RFT ADDENDUM

Nº: 02

Project Number: LI 17-001	Project Name: Lakehead University Law Clinic Phase II Renovations	Location Address: 401 Red River Road, Thunder Bay, ON (PACI)	Project Manager: James McKillop
To: All Bidders	Date: August 3, 2018

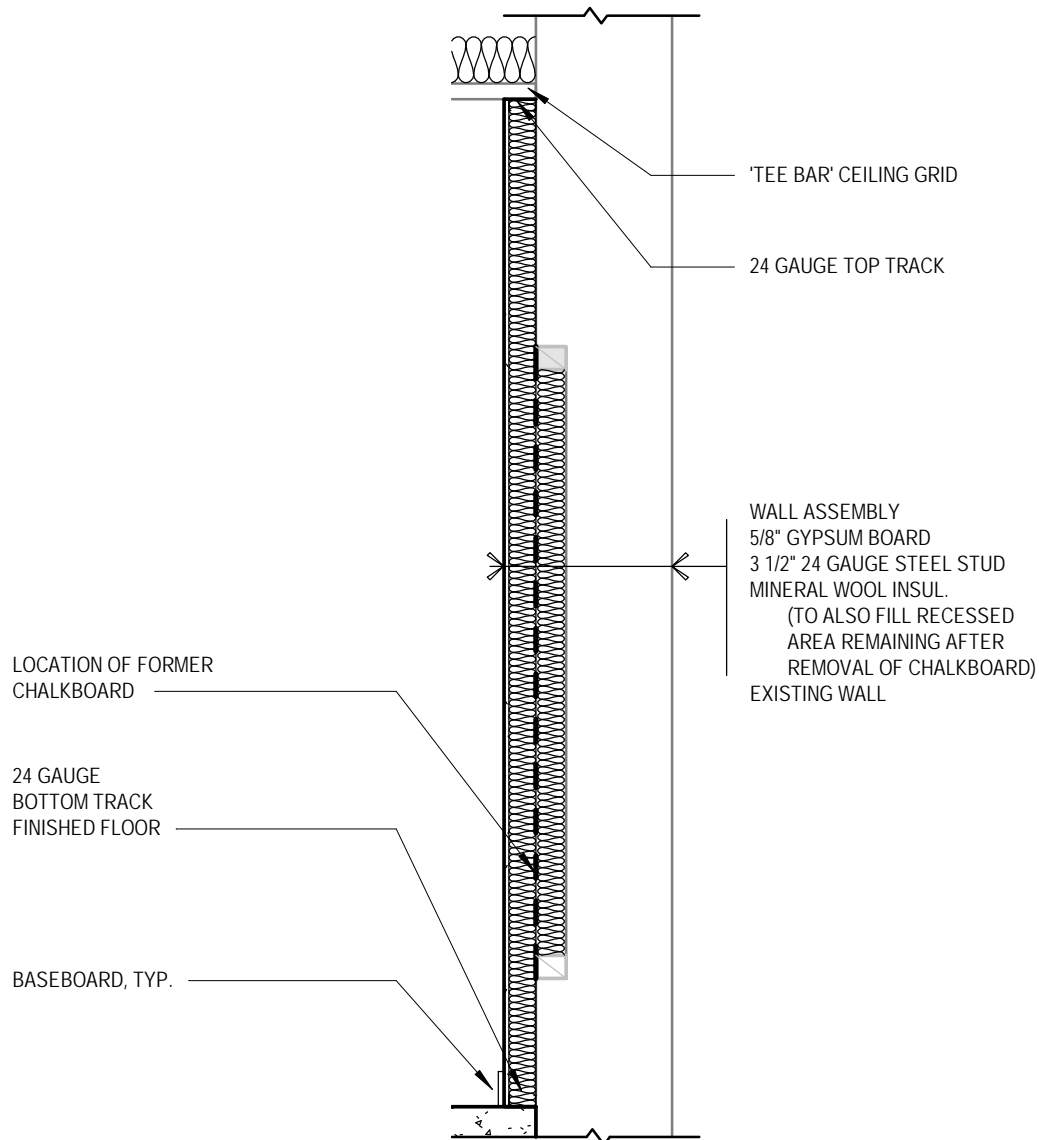
1.9	<p>Removal of Chalk Board: See photos of existing wall assembly behind chalk board. Provide 89mm metal studs @ 400mm o/c complete with 16mm gypsum board painted as per Room Finish Schedule. Relocate electrical to corresponding new wall location. See SK-A1.</p>
PART 2	DRAWINGS
